Please Quote Our Ref: 8389

**RE: Response to information request
Proposed Rooming Accommodation
307 and 307A Riding Road, Balmoral Q 4171
Council reference: A007043089**

Figure 3: Extract of building plans showing bin storage area

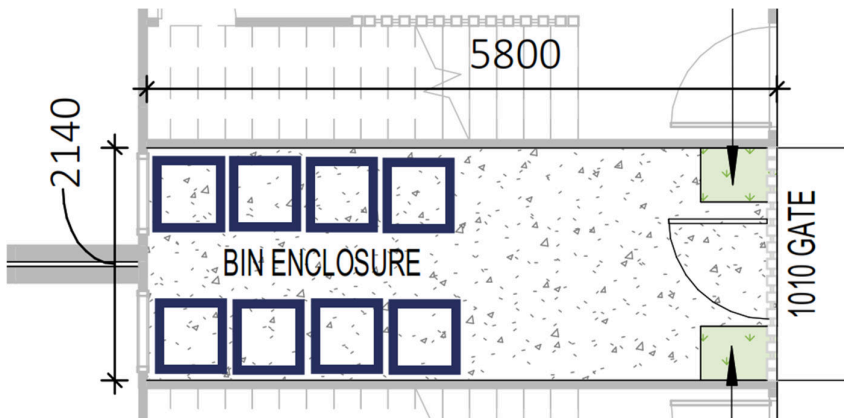
- iii) Demonstrate a refuse storage area of suitable size to accommodate the required capacity for the development i.e. ten (10) 240L Mobile garbage bins. The refuse storage area must not house other services and should not contain or be overlooked by windows. The refuse storage area is to be positioned or contained as to not be visible from the street, public space or an adjacent dwelling sensitive use.

In summary, on-site collection is non-viable, however it has been demonstrated that only 8 x 240L mobile bins are needed and can be accommodated within the verge on collection day. In addition, adequately sized bin storage is available on site, ensuring bins are not visible from the street.
